Subject: Scheduling of Ordinance – Amending Zoning at 644-664 Crown Street in Walnut Hills

SUBJECT: A report and recommendation on a proposed zone change from T4N.SF (Transect Zone 4 Neighborhood Small Footprint) to T5N.LS-O (Transect Zone 5 Neighborhood Large Setback, Open Sub-Zone) located at 644-664 Crown Street in Walnut Hills.

Re: 644-664 Crown Street | May Square (P) – (CPRE200017) Initial Comments and Recommendations

EXISTING CONDITIONS

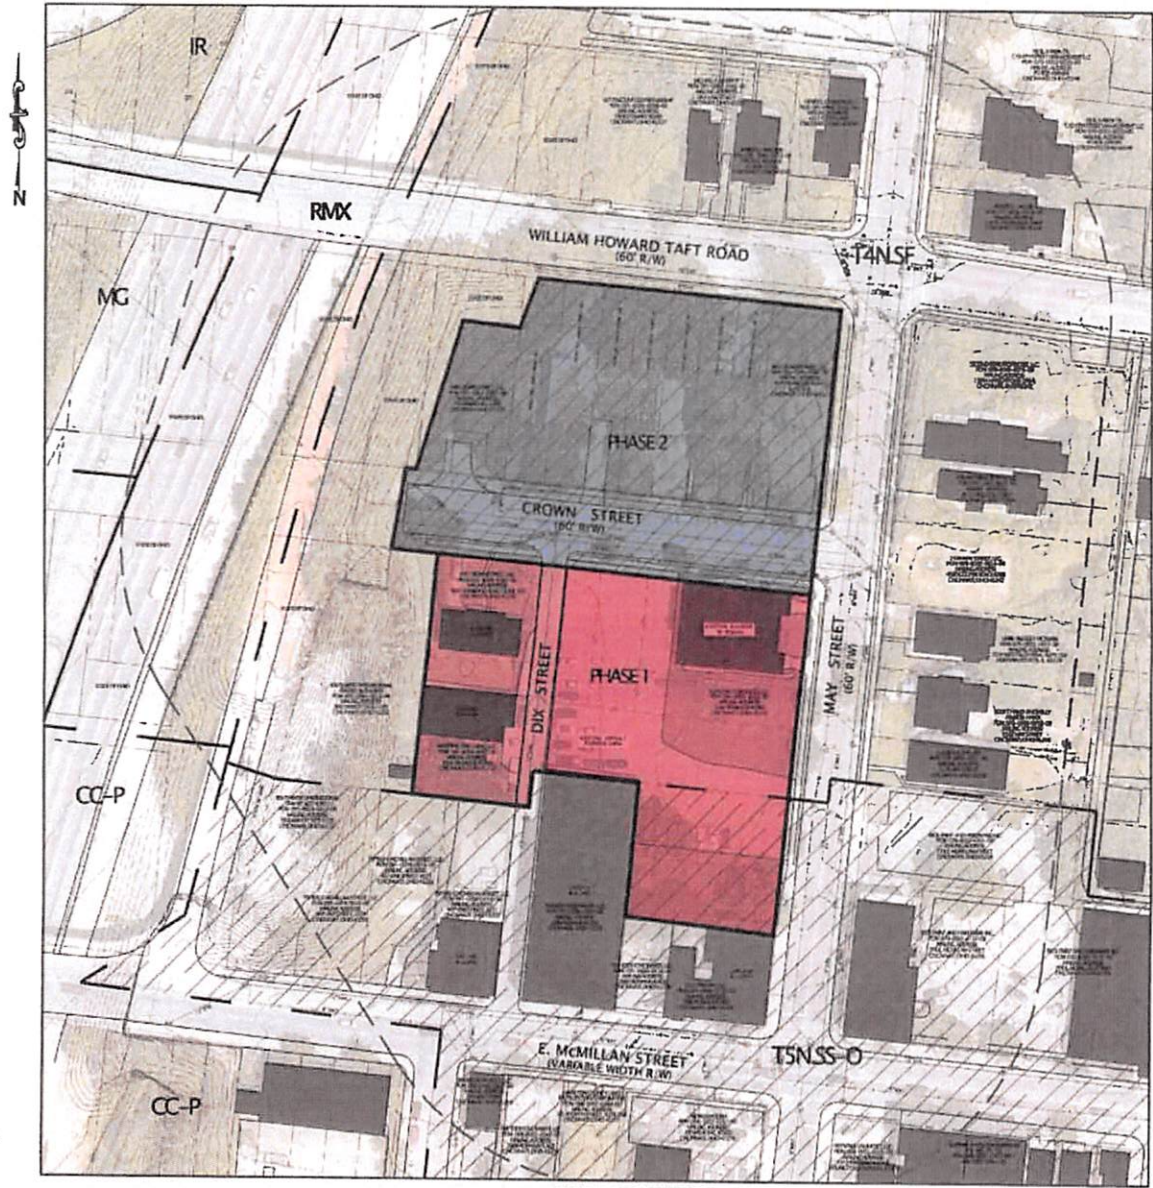
4. If a Zone Change to T5N.LS-O occurs:
 - o More detailed plans including elevations will be required for a full review and evaluation of necessary zoning relief. Please note, T5N.LS-O requires 15' minimum front setbacks and proposed setbacks are currently <10'.

10. SMU does not permit Public inlets with 5' of curb aprons. Show that clearance is achieved at northernmost driveway off of May St.

1. Must remain same grade on Crown Street and remain Public Right-of-Way to maintain the existing 48" & 6" public water mains in Crown Street.
2. **The drawing submitted shows an enclosure out in the right-of-way over the 48-inch water main and will not be permitted.**
